DEVELOPMENT REVIEW COMMITTEE (DRC) COMMENT REPORT

MEETING DATE: May 28, 2019

PROJECT NAME: InterMiami Lockhart Training Center and Stadium

CASE NUMBER: R19036

VISION ZERO SAFER STREETS FOR FORT LAUDERDALE

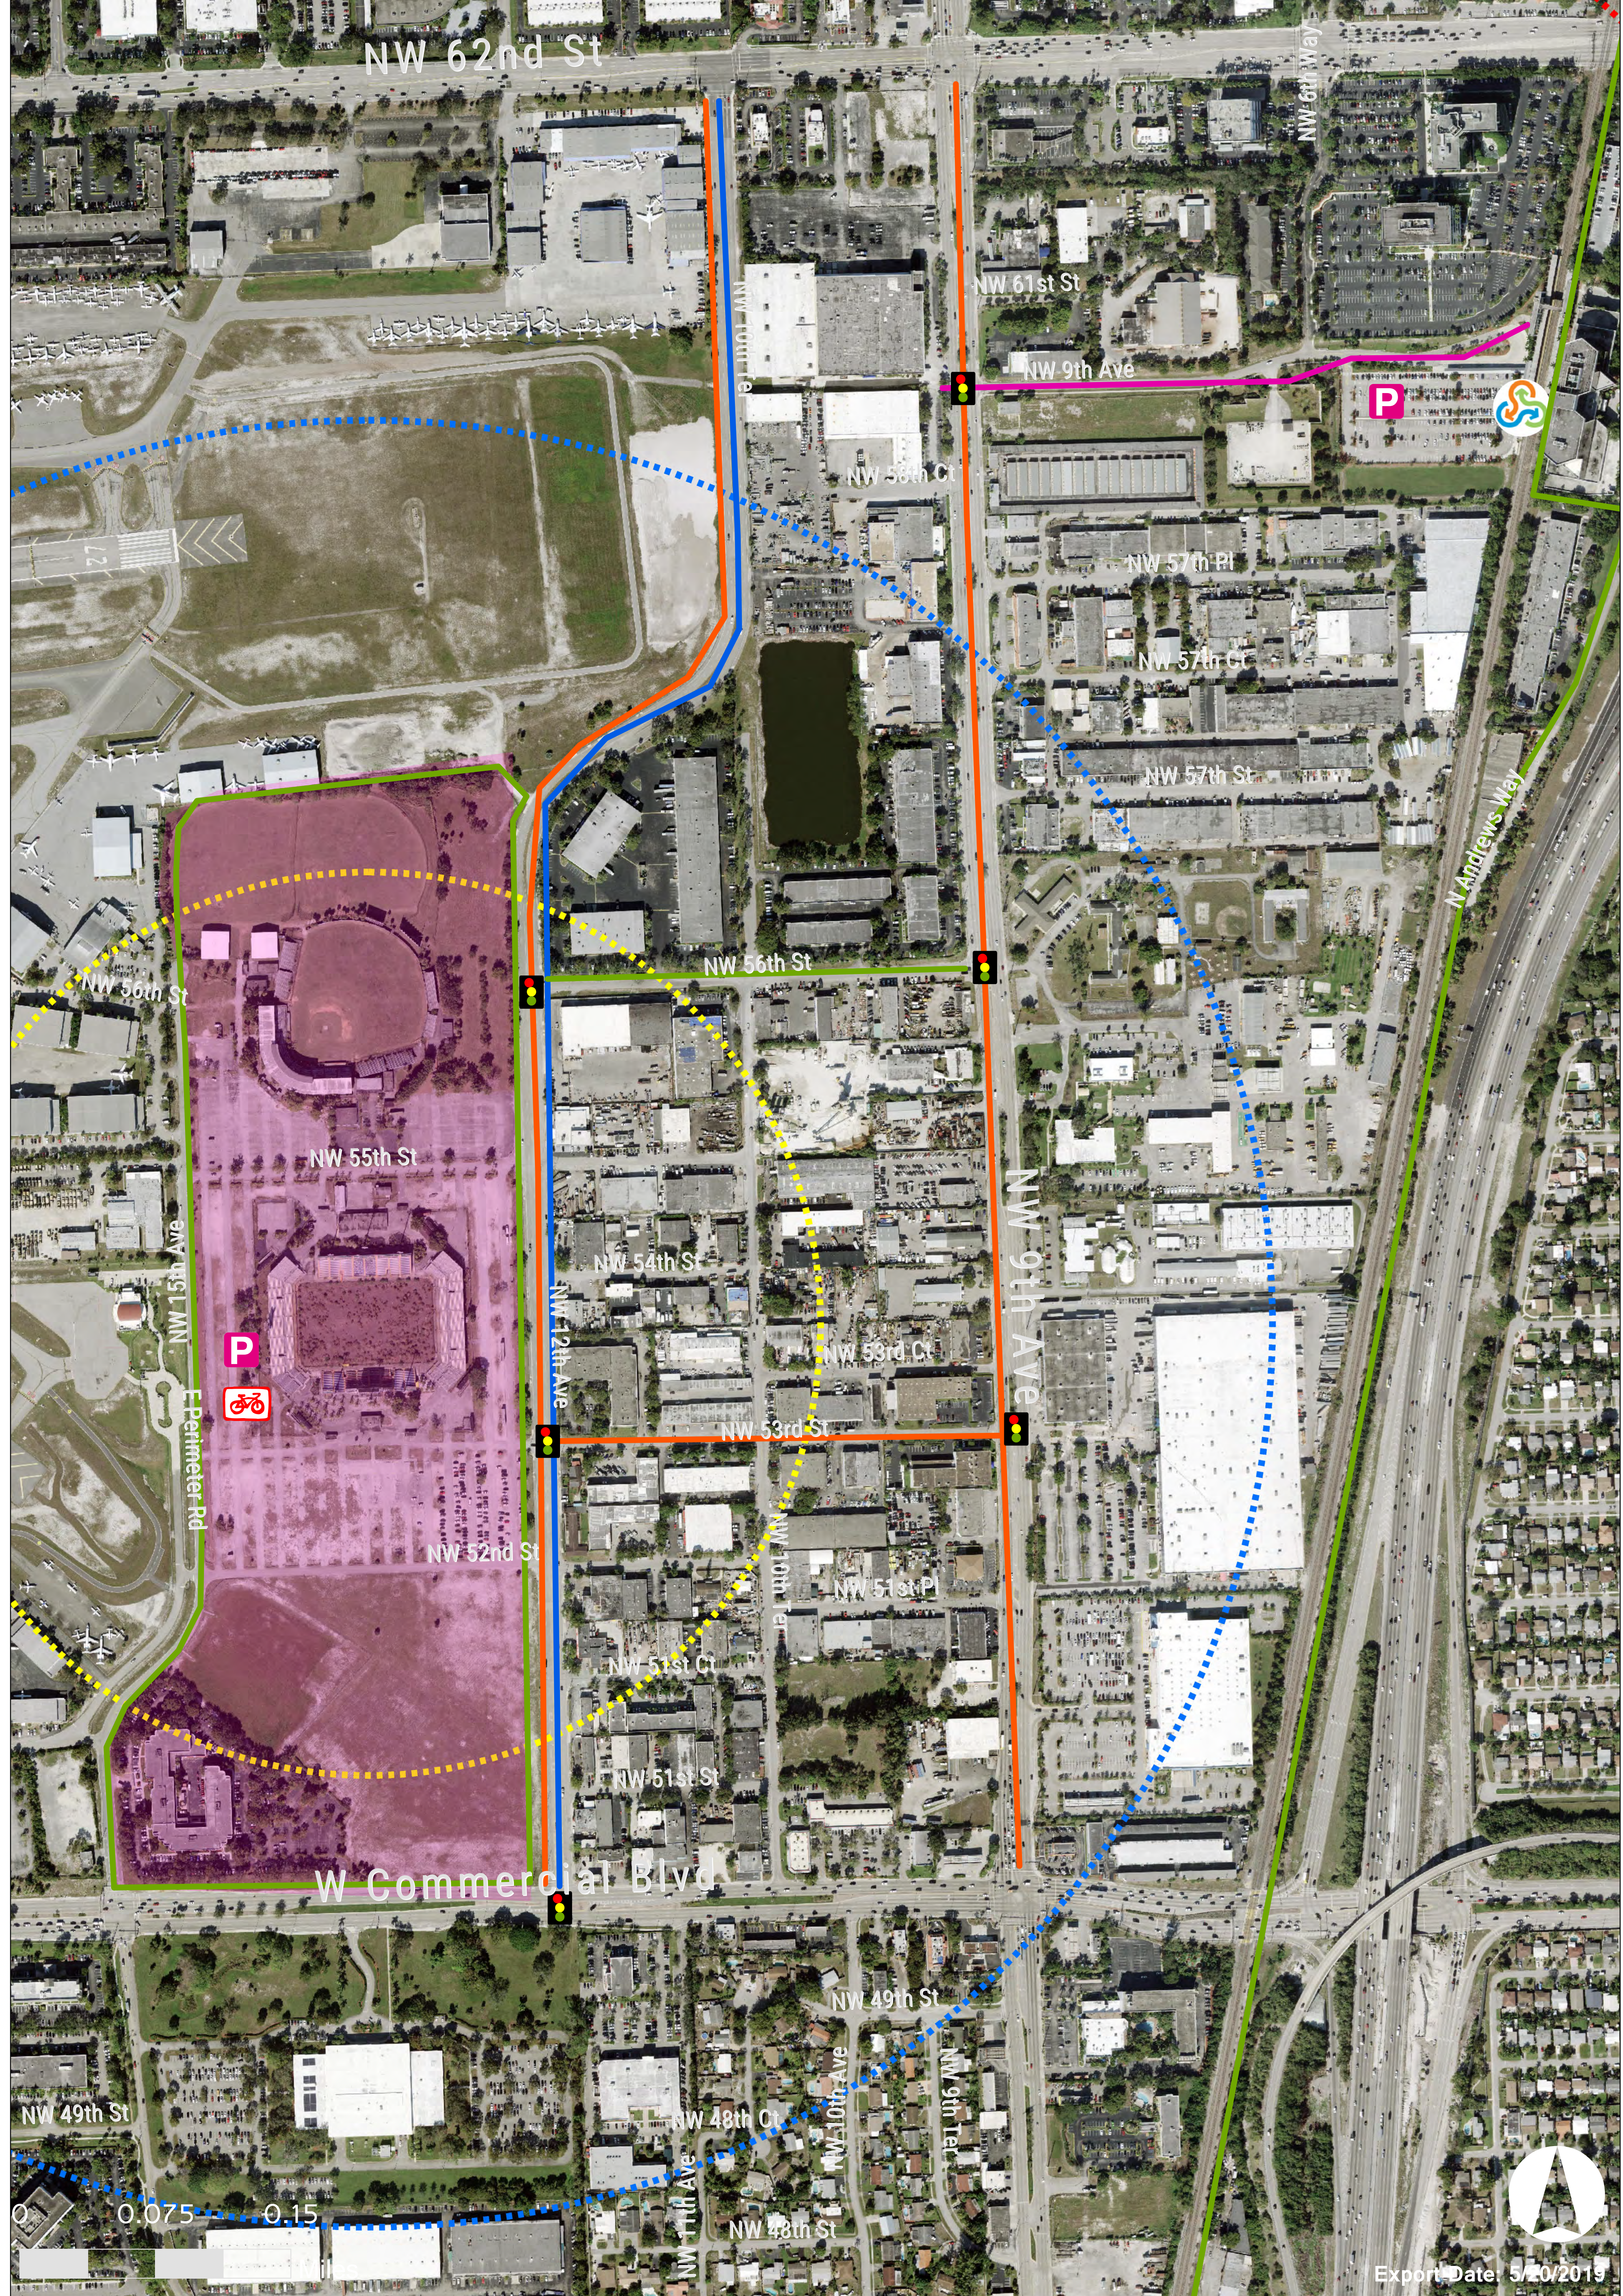
7. Please refer to the attached graphic for possible mitigations ideas to offset traffic impacts or improve traffic flow. Traffic mitigations will be determined through the results of the traffic study.
